IEEE P802.11

**Proposed Text for Section 5.4,  
Based on responses to Draft D1 Letter Ballot processed at  
March 1995 Meeting**

**Abstract:** This paper presents the changes to section 5.4 in the Draft Standard P802.11/D1 as a result of the Response to Draft D1 Letter Ballot processed at the March 1995 Meeting . Not all Letter Ballot comments were processed at the March 1995 Meeting.

**Action:** Adopt the changes in this paper to replace the relevent portions of Section 5.4 of P802.11/D1.

Figure 5-22: WEP Encipherment Block Diagram

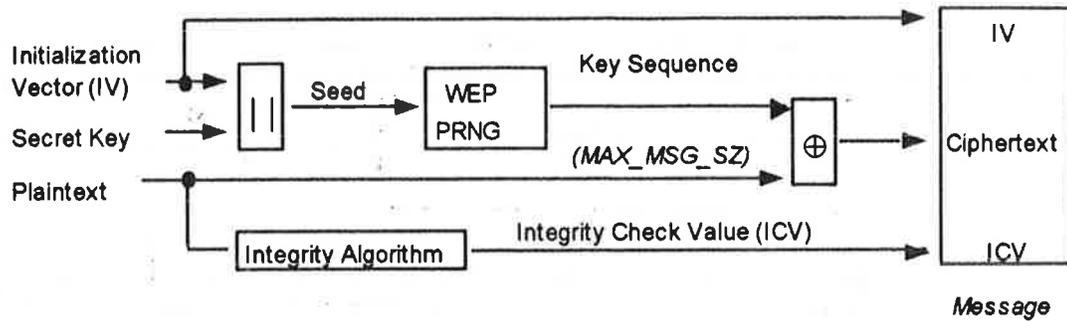
The secret key is *concated with* combined with an initialization vector (IV) and the resulting **seed** is input to a **pseudo random number generator (PRNG)**. The PRNG outputs a **key sequence**  $k$  of pseudo-random bits equal in length to the largest possible MSDU. Two processes are applied to the plaintext MSDU. To protect against unauthorized data modification, an integrity algorithm operates on  $P$  to produce an **integrity check value (ICV)**. Encipherment is then accomplished by mathematically combining the key sequence with  $P$ . The output of the process is a **message** containing the resulting ciphertext, the IV, and the ICV.

Figure 5-23: WEP Decipherment Block Diagram

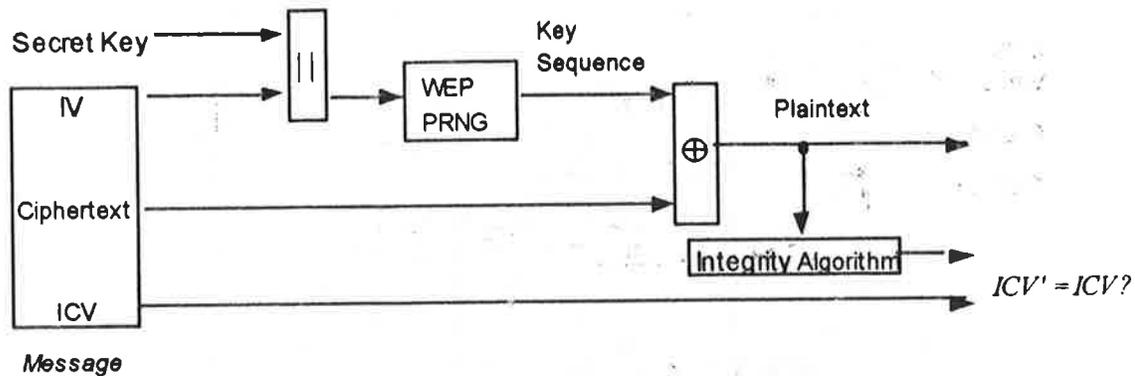
Referring to Figure 5-23 and following from left to right, decipherment begins with the arrival of a message. The IV of the incoming message is used to generate the key sequence necessary to decipher the incoming message. Combining the ciphertext with the proper key sequence yields the original plaintext. *Correct decipherment is desired, this may be verified by performing the integrity algorithm on the recovered plaintext and comparing the output ICV' to the ICV transmitted with the message. If ICV' is not equal to ICV, the received MSDU is not passed to LLC and an error indication is sent to MAC management.*

Figure 5-24: Construction of WEP SDE\_PDU

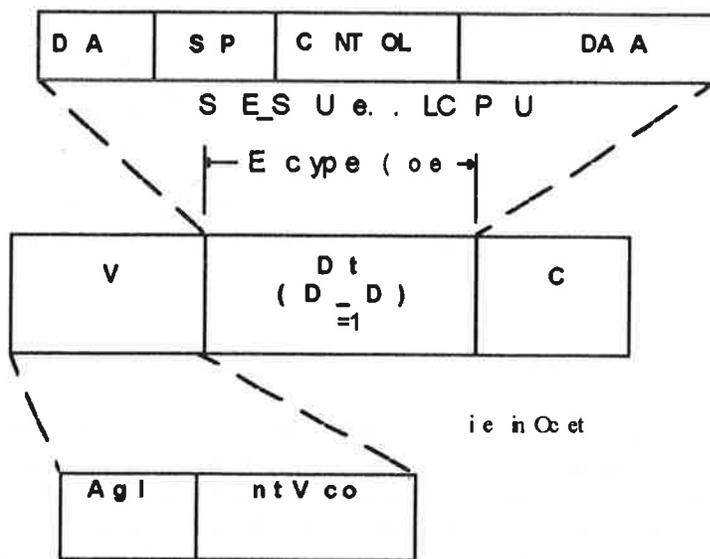
*The WEP uses a subset of the IEEE 802.10 SDE structure shown in Figure 3-1 of section 3.1.1.3. Figure 5-24 shows the SDE\_PDU as constructed by the WEP.*

*The 802.10 SDE settings for 802.11 WEP shall be clear header length =null, protected header length =null, pad =null, and ICV = 32 bits. The data field shall include a 32-bit IV field immediately preceding the MSDU. This field shall contain two sub-fields: A 1-octet field that contains the confidentiality algorithm ID, and a 3-octet field that contains the initialization vector.*
